**ADDENDUM NO. 7  
PROJECT BI-CTC-455**

Date: June 12, 2015  
Renovations and Addition to Lafayette Hall  
Housatonic Community College  
Bridgeport, CT

## ADDENDUM #7

Renovations and New Addition to Lafayette Hall  
Housatonic Community College  
Bridgeport, Connecticut

**AD7-A1**

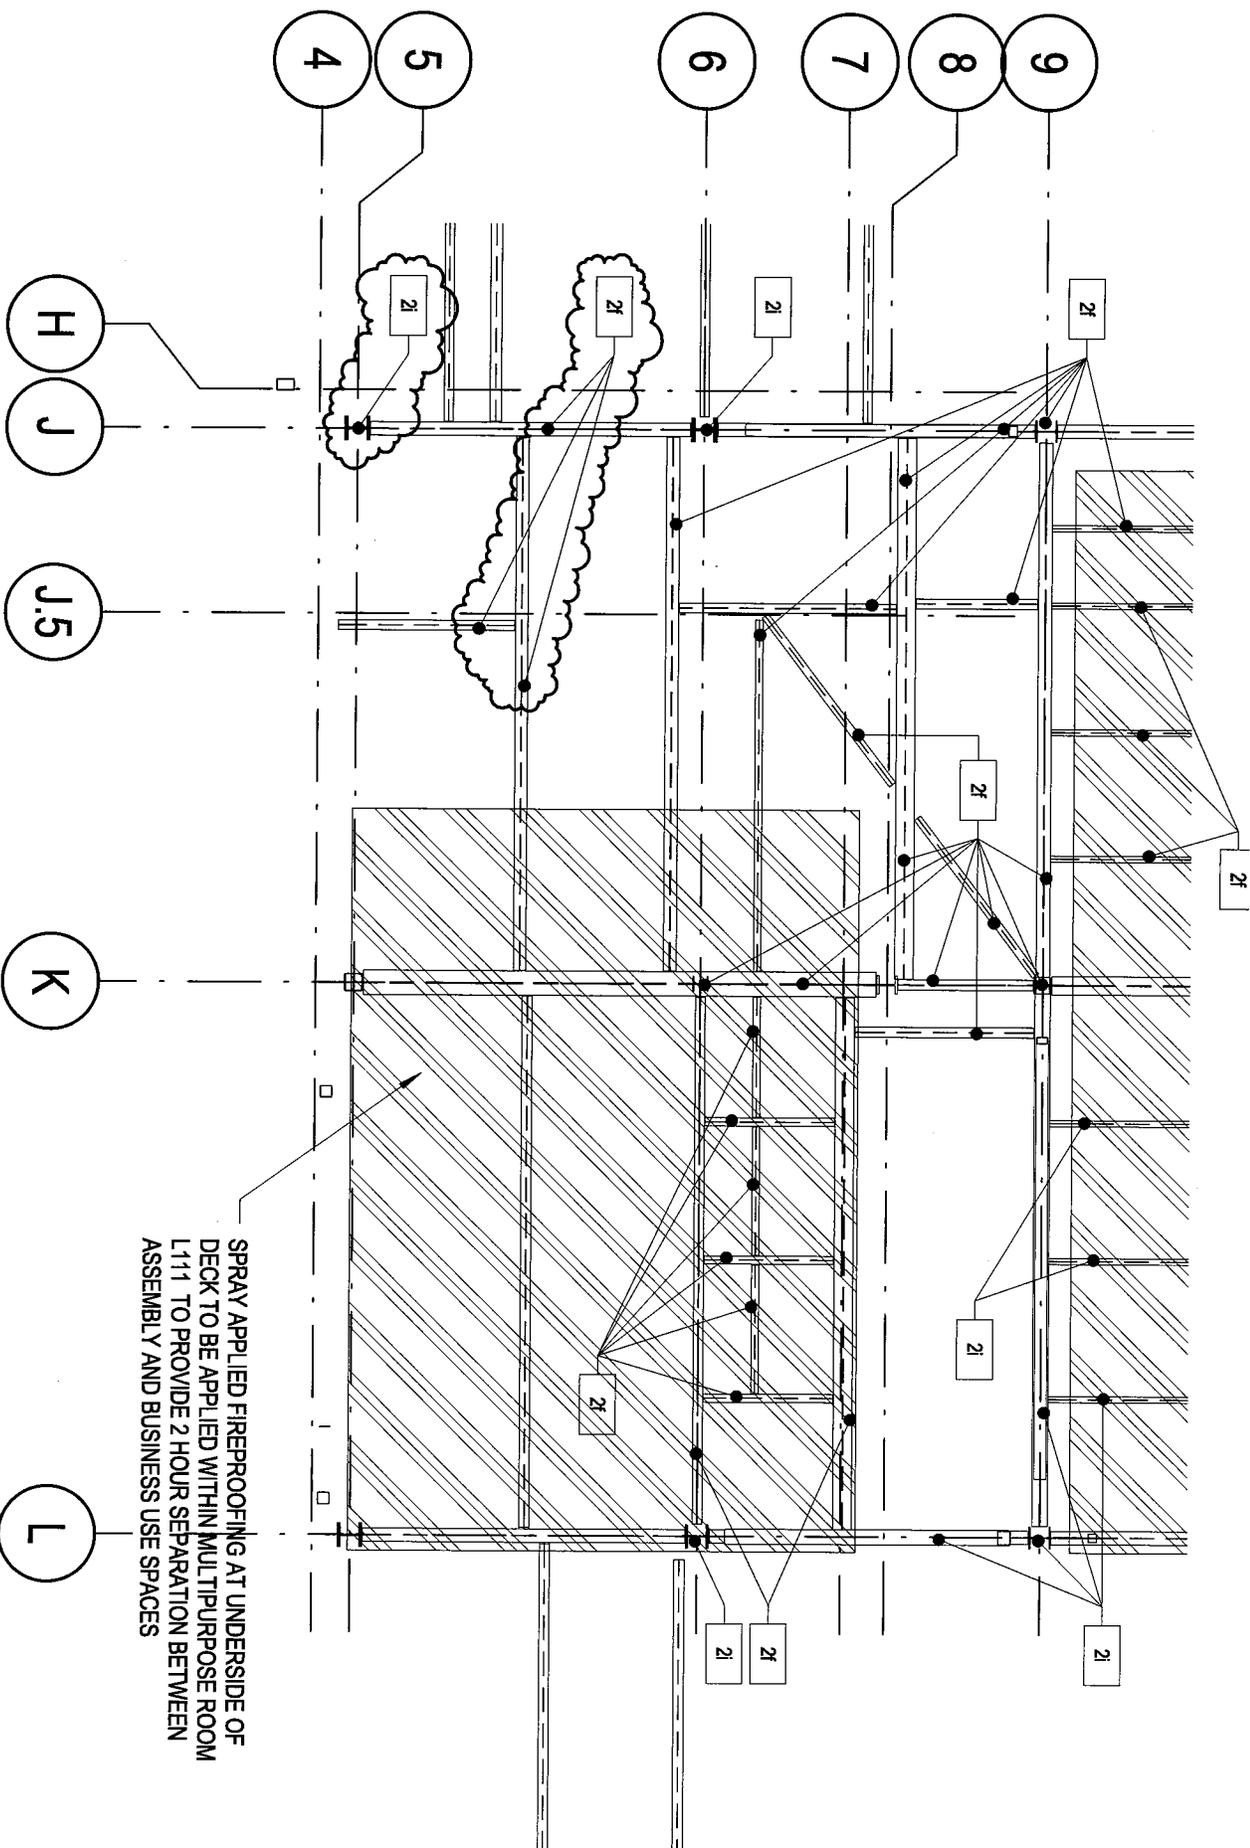
- Fireproofing Diagram – 2<sup>nd</sup> Floor Framing: **ADD** designation 2i and 2f to area between column lines 4 and 6 and J and L as indicated on sketch AD7-A1.

SPRAY APPLIED FIREPROOFING AT UNDERSIDE OF DECK TO BE APPLIED WITHIN MULTIPURPOSE ROOM L111 TO PROVIDE 2 HOUR SEPARATION BETWEEN ASSEMBLY AND BUSINESS USE SPACES

AD7-A2

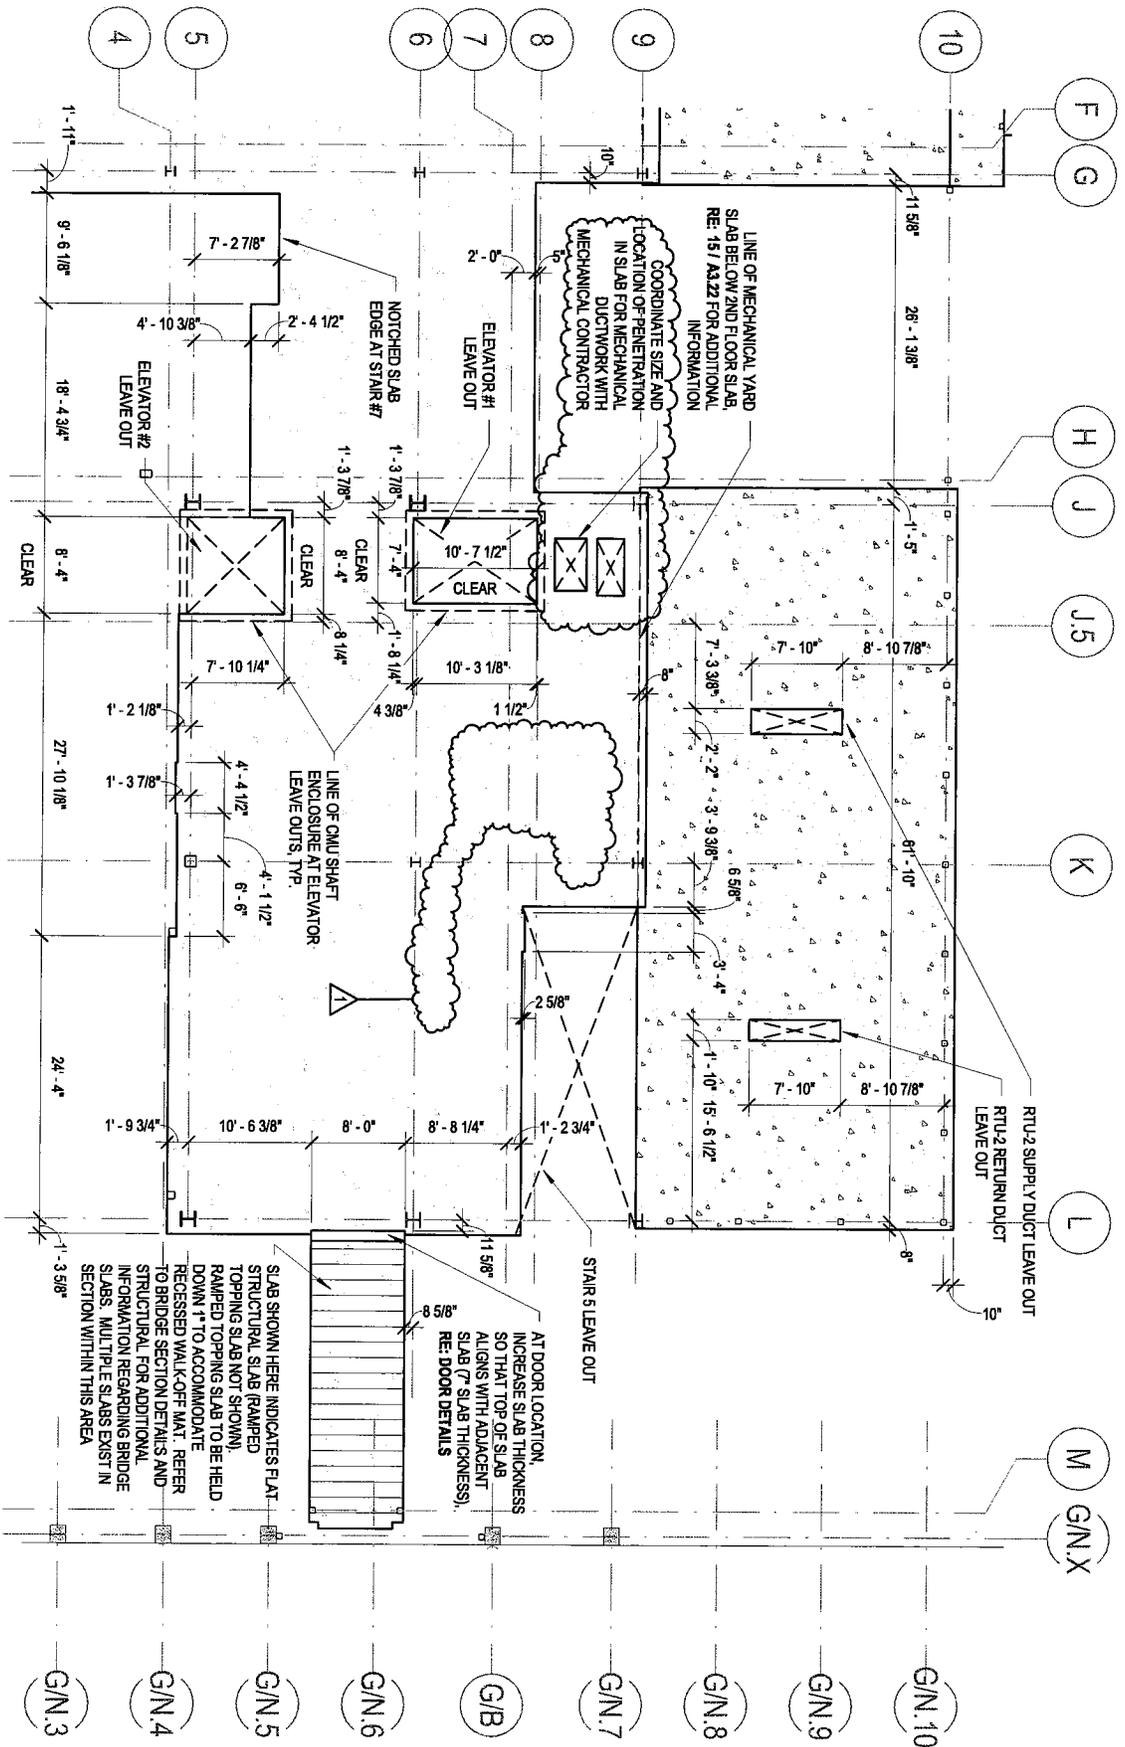
- Second Floor Addition Slab Edge Plan: **MODIFY** slab edge at column line intersection "J-9" as indicated on sketch AD7-A2.
- Second Floor Addition Slab Edge Plan: **DELETE** slab opening adjacent to column line intersection "K-8" as indicated on sketch AD7-A2.

**AD7-S1**

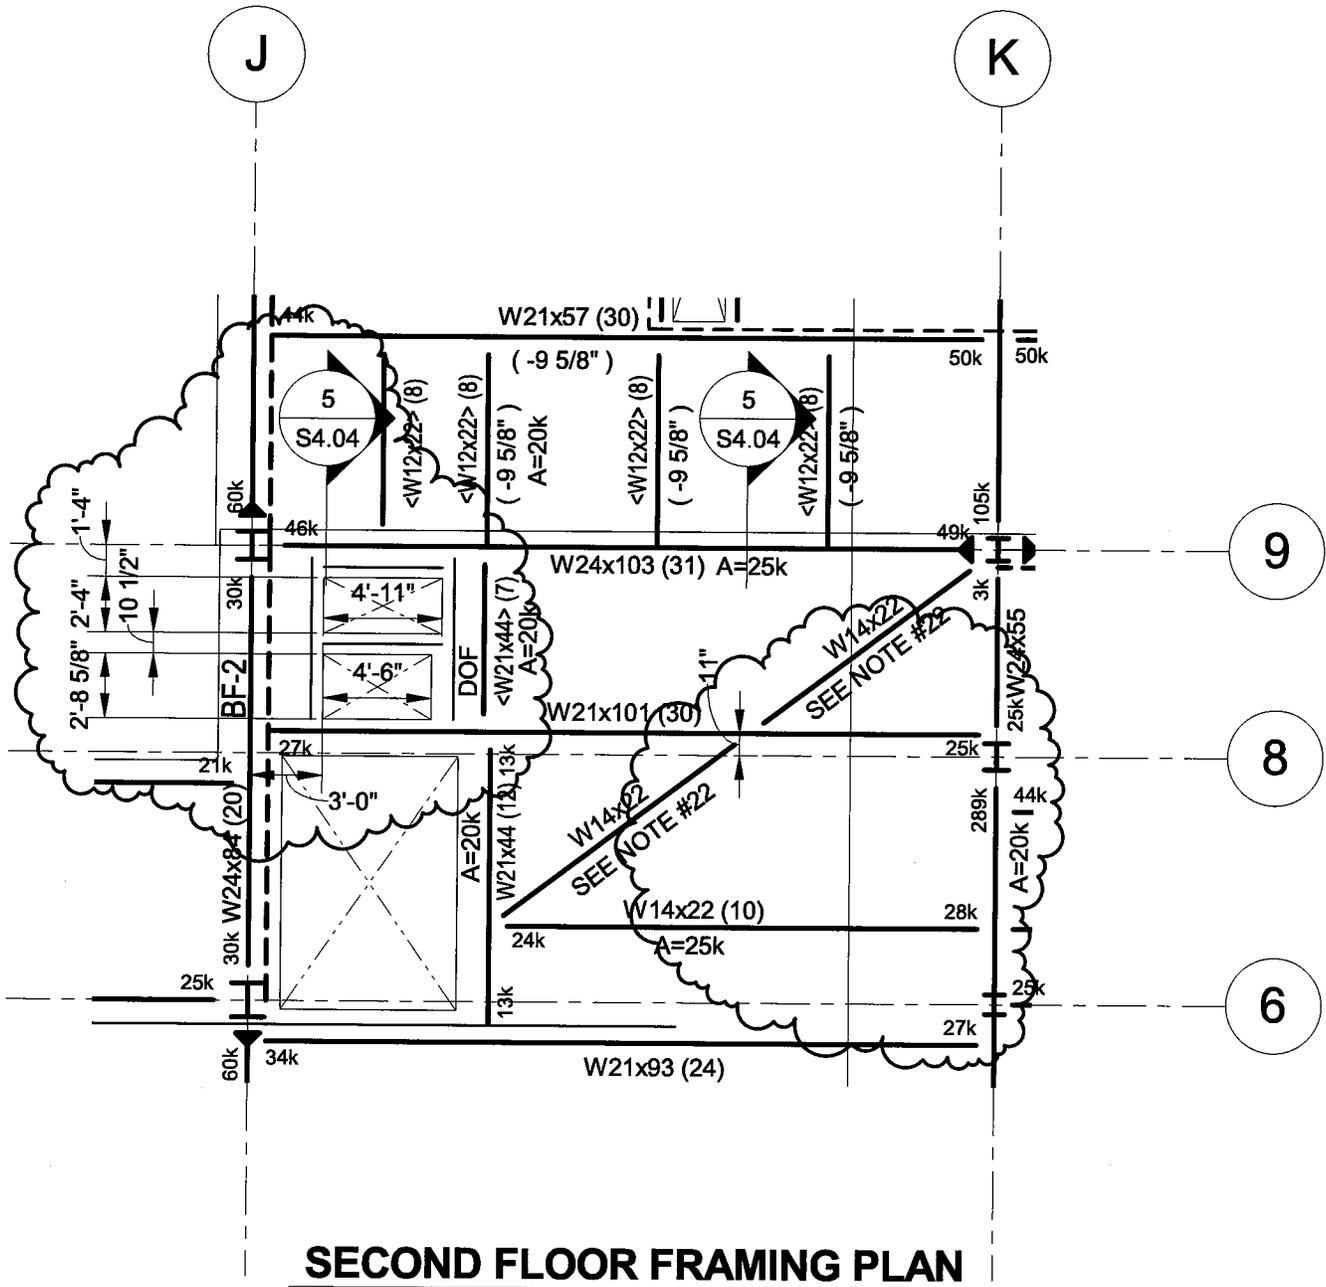
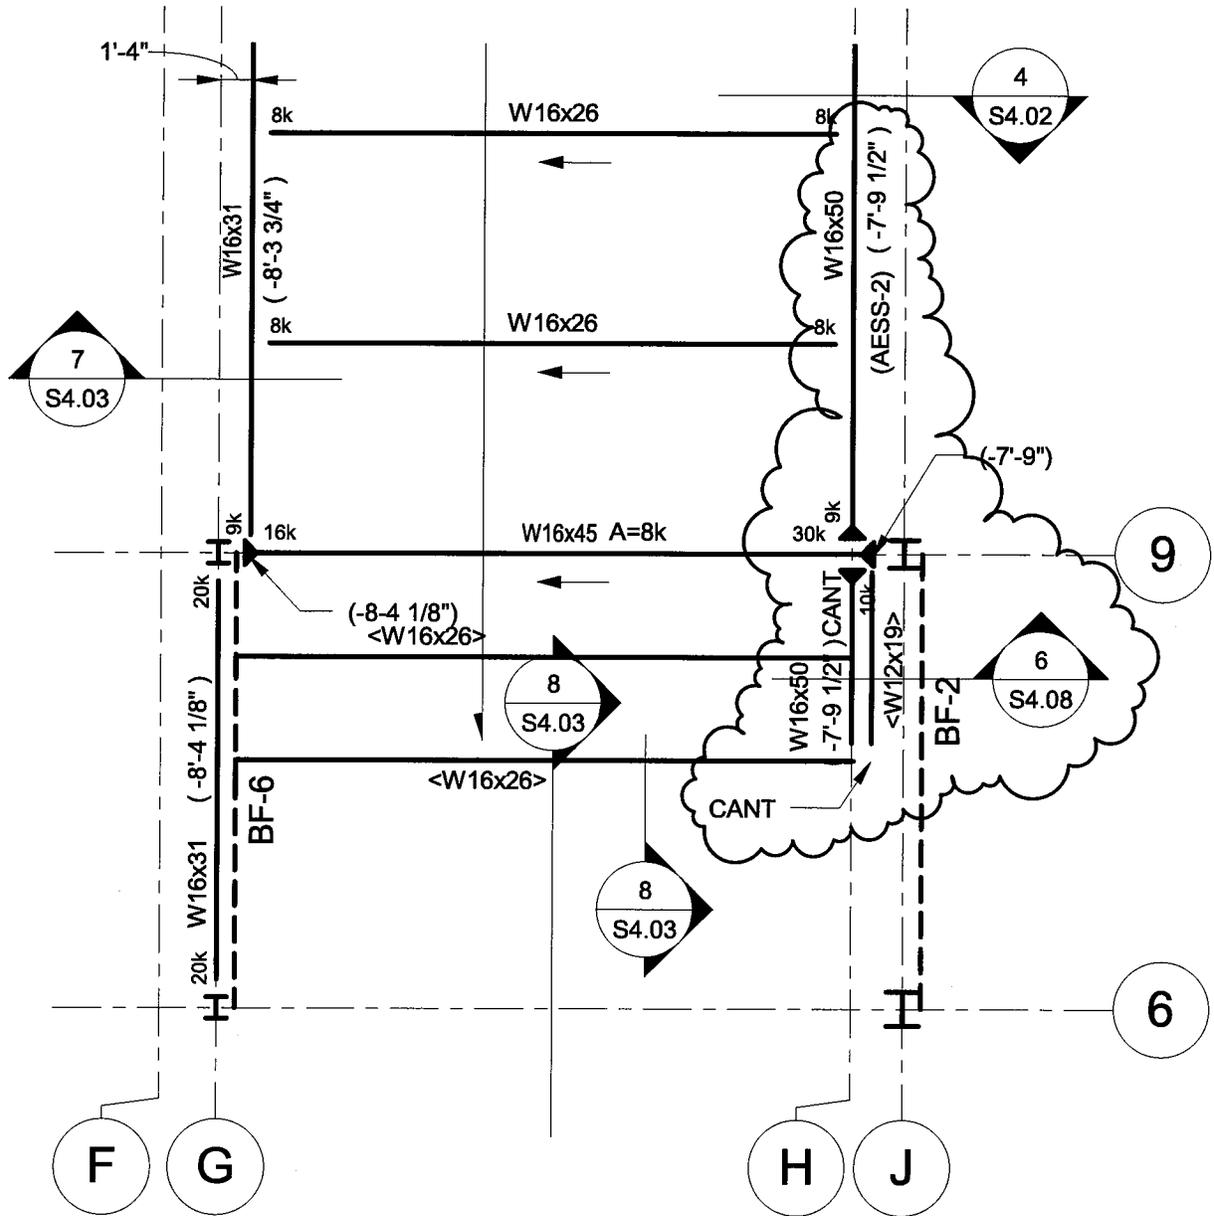
- Second Floor Framing Plan: **MODIFY** edge of slab at column line intersection "J-9" as indicated on sketch AD7-S1.
- Second Floor Framing Plan: **DELETE** slab opening and deck opening frame adjacent to column line intersection "K-8" as indicated on sketch AD7-S1.

# AD7-S2

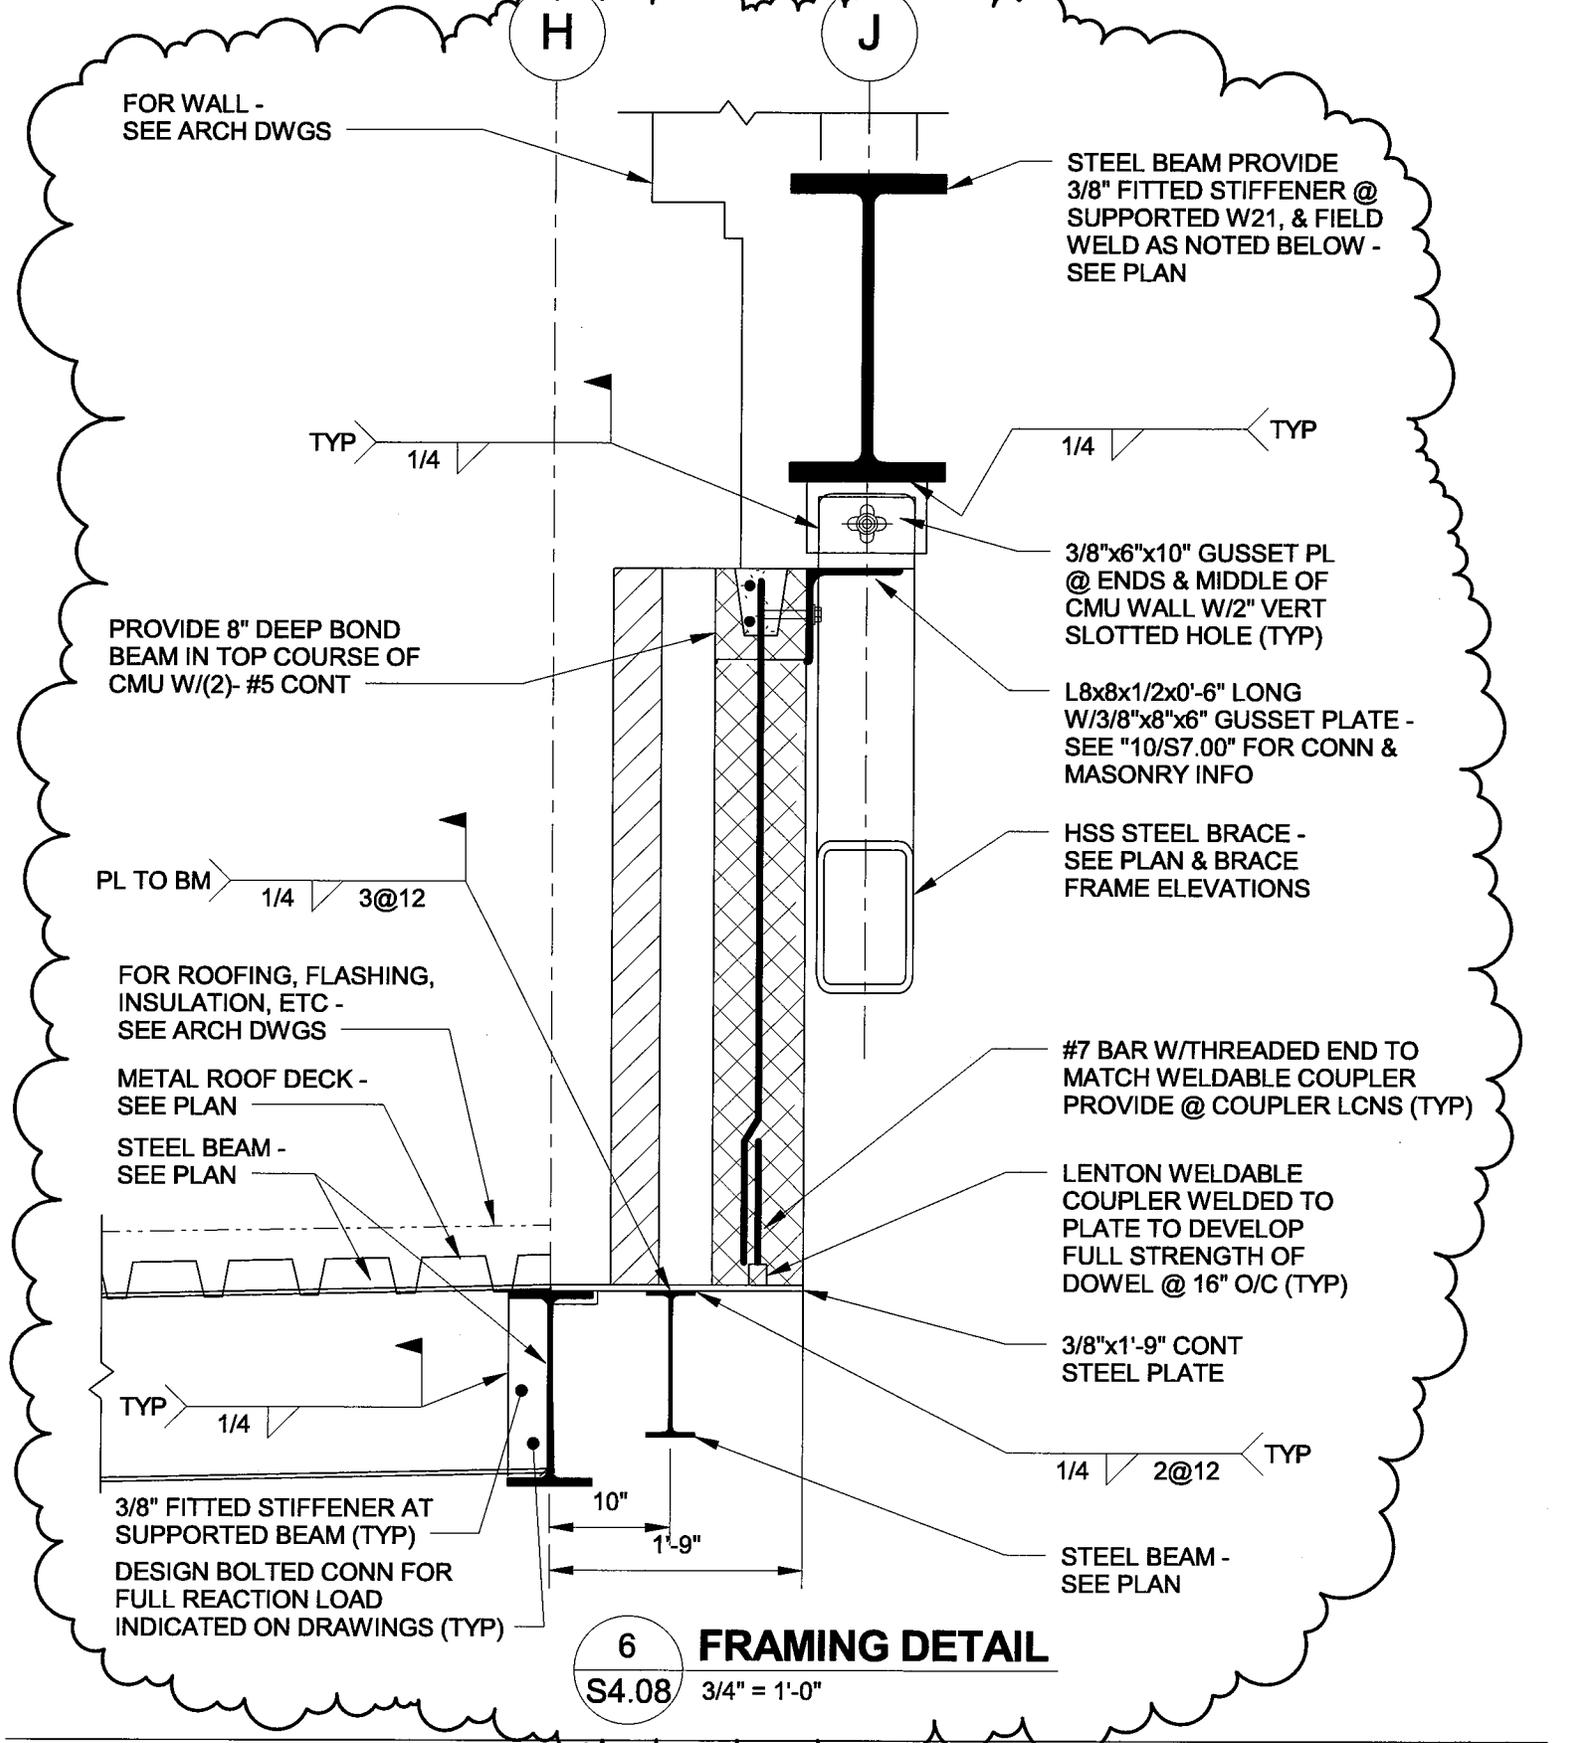
- Lobby Roof Framing Plan: **ADD** steel beam adjacent to column line intersection "J-9" as indicated on sketch AD7-S2.
